FIRST STREET

FINAL DEVELOPMENT PLAN

PB #231A, AMENDMENT 3 | PUD SPECIAL PERMIT APPLICATION

Case Number 231A, Amendment 3 (Major)

Weekday Pedestrians - ½ Hour @ Lunch Time

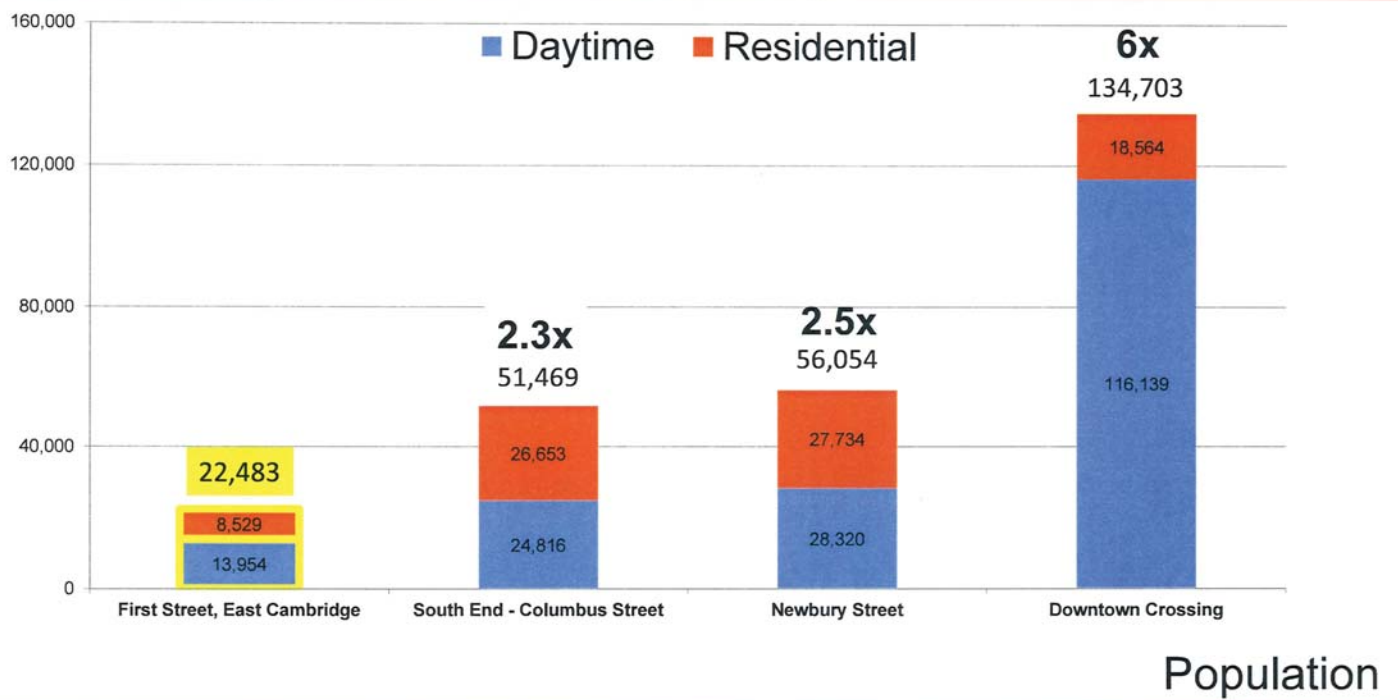
Lunchtime pedestrian activity was found to be fewer than 100 pedestrians per half hour. By contrast, pedestrian activity during that same time period in Harvard, Kendall and Central Squares exceed that level by multiples of four and five (see attached). With the buildout of this project and the surrounding area it is reasonable to anticipate that the pedestrian activity on First Street over the next decade will increase. However, the likely rate of increase in the next decade will still require parking in order to attract retailers who will need to succeed in this location at the outset of their tenancies.
